[Docket No. FAA-2020-1120; Project Identifier 2019-SW-056-AD; Amendment 39-21962; AD 2022-05-10]

Airworthiness Directives; Goodrich Externally-Mounted Hoist Assemblies

ACTION: Final rule.

Figure 3 to Paragraph (g)(2)(iii)

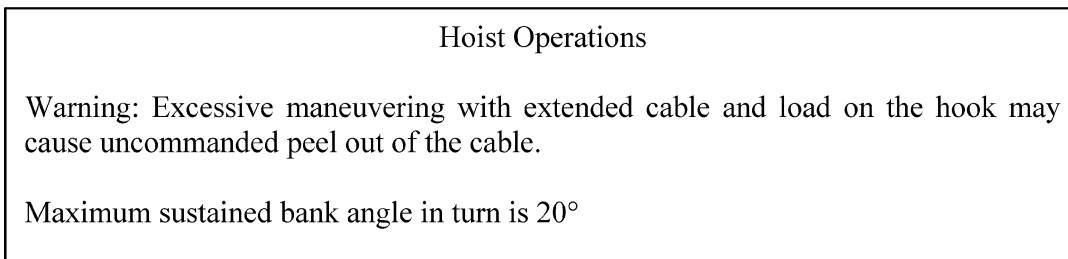
In the SNPRM, the FAA proposed to require a placard and RFM limitation that warned the pilot about excessive maneuvering with a load on an extended cable and limited the maximum sustained bank angle to 20 degrees. Bell Canada stated that limits on bank angle (and pendulum angle) are difficult to monitor by aircrew and will increase crew workload, and therefore prohibiting maneuvering with load on extended cable is necessary to manage the risk of clutch slippage. The FAA infers that Bell Canada is requesting the FAA prohibit maneuvering with load on

In the SNPRM, the FAA proposed to require a placard and revision to the RFM to reduce the weight limitations for the hoist load based on the outside air temperature. Bell Canada stated that the FAA's proposed limitations include a de-rating factor of 50 lbs, which is not warranted for Bell Canada Model 429 and 430 helicopters. In support, Bell Canada stated that the de-rating factor was established to accommodate certain maneuvering, which has been prohibited for the Bell Canada products.

Collins Aerospace requested the FAA change the proposed maximum hoist load limitations to distinguishing between non-modified hoists (without the number "4" as the first digit of its serial number (S/N)) and modified hoists with a new clutch (with the number "4" as the first digit of its S/N). Collins Aerospace stated that after EASA AD 2015–0226R1 was issued, Goodrich performed a series of characterization tests that demonstrated the performance envelope of the modified hoist in various conditions. According to Collins Aerospace, the results of these tests as documented in Goodrich Report No. 49000–1087, Revision A, dated July 31, 2017, indicate that margins are maintained with a less restrictive temperature limitation than those imposed on non-modified hoists.

The FAA disagrees with changing the flight limitation from a bank angle limit to a maneuvering prohibition. The FAA determined that limiting the bank angle in conjunction with a reduced maximum load mitigates the unsafe condition. The attitude indicator, which is used by the pilot to monitor the bank angle while maneuvering an external load, is in the pilot's normal field of view and is regularly monitored; therefore, any additional workload is minimal. The FAA does agree that requiring the aircrew to monitor the lateral pendulum angle of the hoist cable with respect to the helicopter's vertical axis would not be an acceptable limitation because it would not be measurable or enforceable.

The FAA determined the de-rating factor is necessary because it directly correlates to the bank angle limitation required by this AD.

As the FAA explained in the SNPRM, the FAA disagrees with requiring different maximum hoist load limitations for non-modified hoists and modified hoists. After reviewing the data in the report referenced by the

commenter, the FAA determined it does not demonstrate with an acceptable level of confidence that less restrictive temperature limitations are appropriate for modified hoists.
